PLAN No. 177

APPLICATION TO ALTER, REPAIR, ETC.

Plan No. 2796

# APPLICATION TO ALTER, REPAIR, Etc.

Basement Plan.  
 543 East 11<sup>th</sup> Str.  
 1/4 Scale.  
 # 177 All.  
 of 1888.

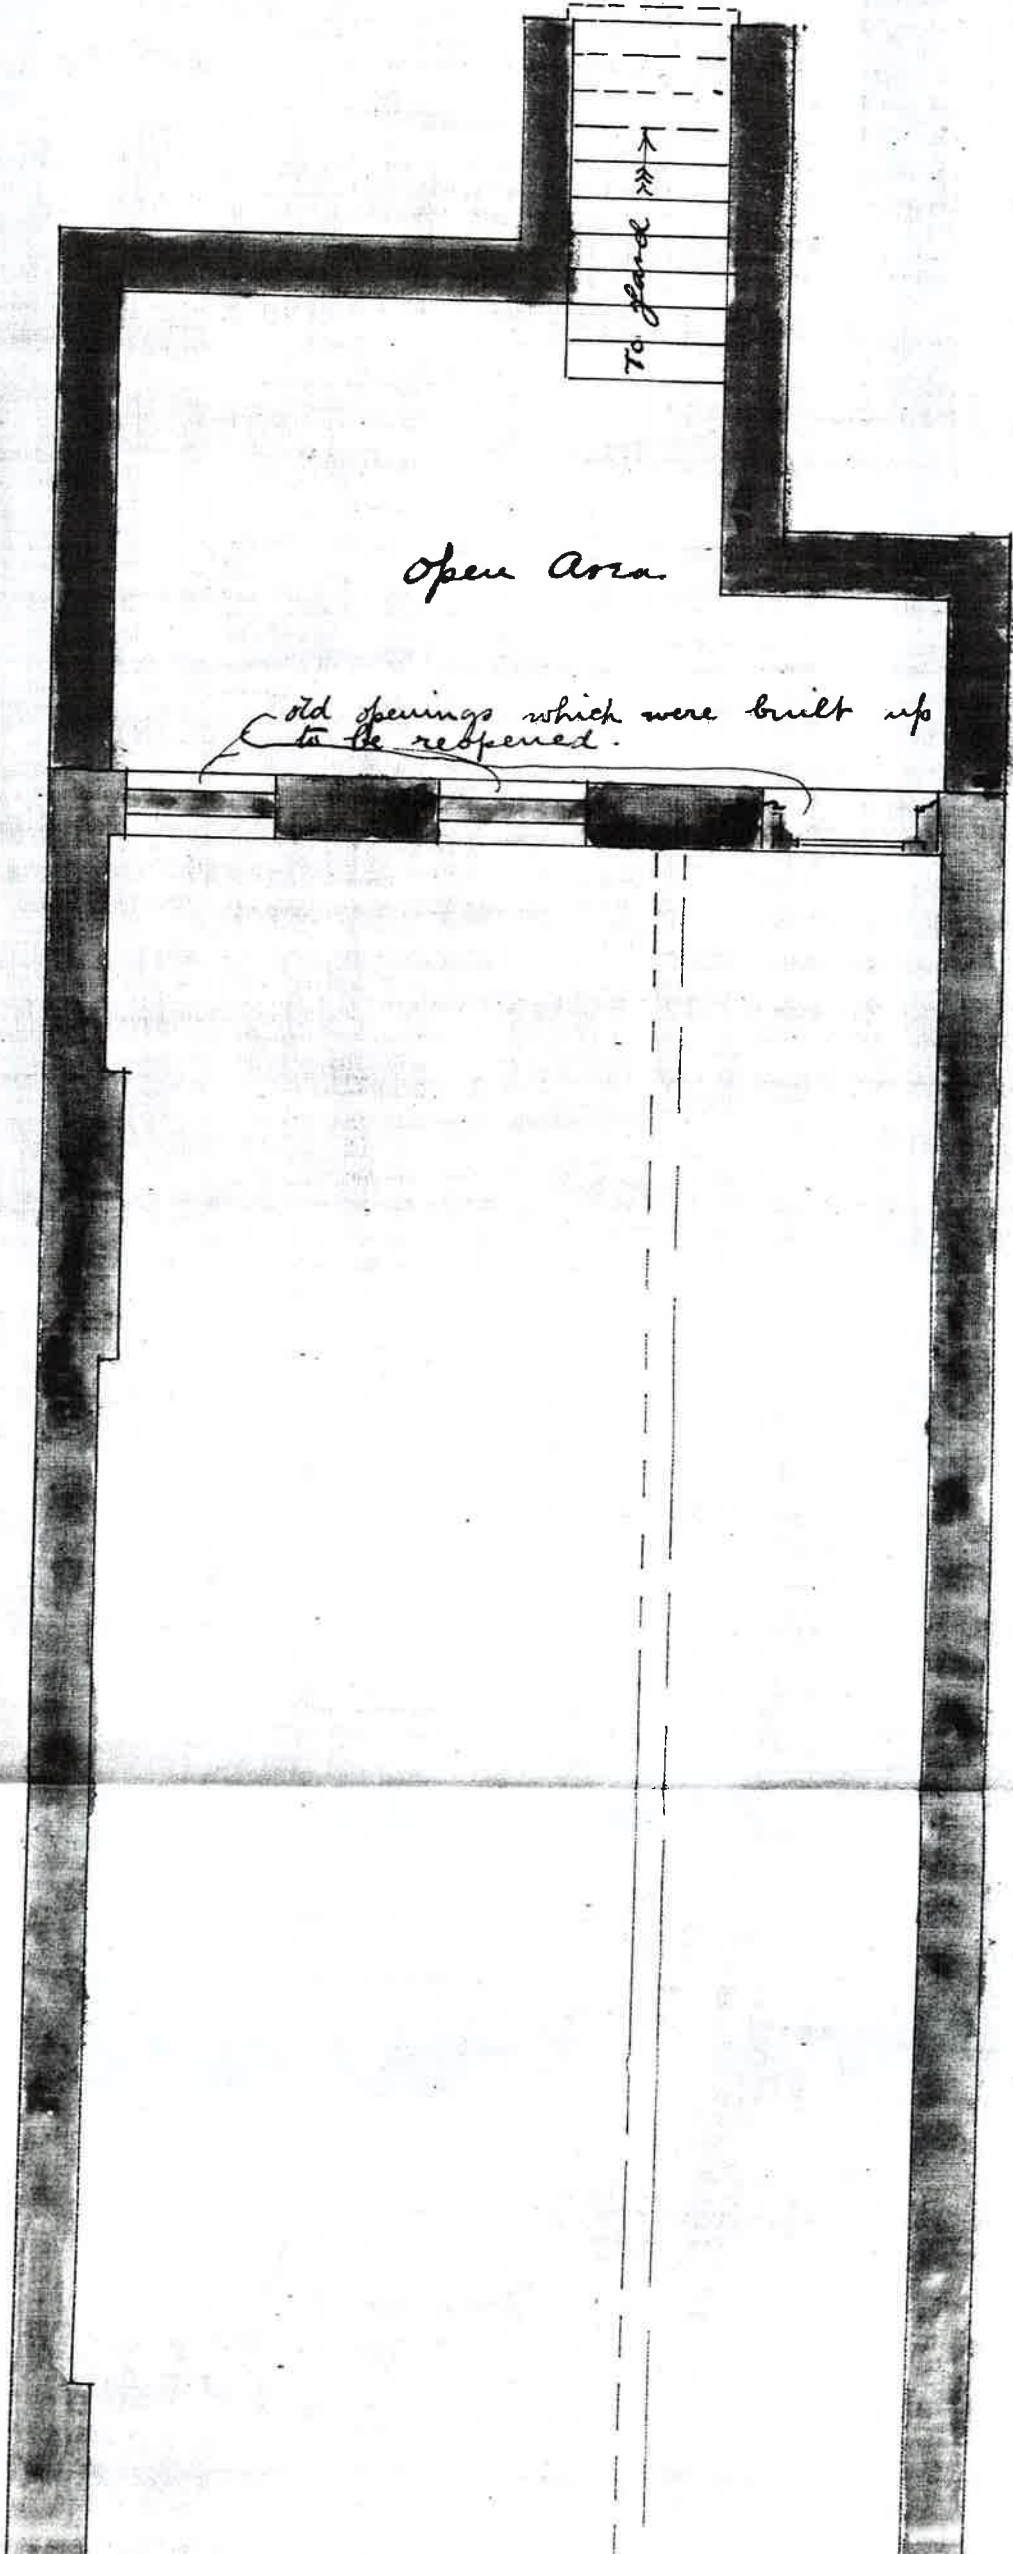
old openings which were built up to be reopened.
